## PLAN REVIEW SHEET

**Petition:** 2012-045

**WAITING PAD ONLY  
WITH PLANTING STRIP**

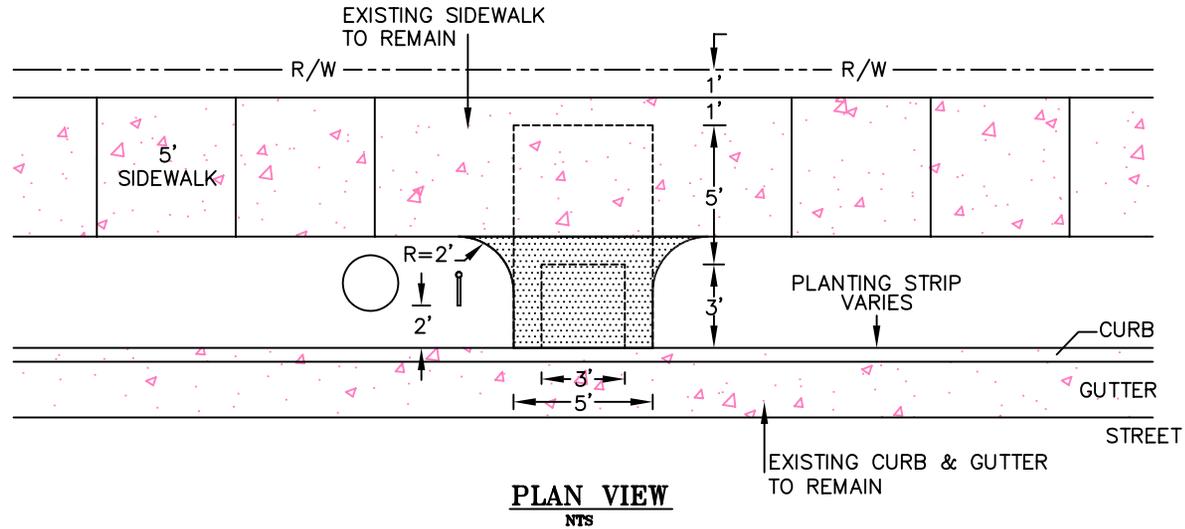
CATS requests that Petitioner provide a concrete waiting pad for bus patrons. If there are any questions regarding this request, please contact CATS. Thank you.
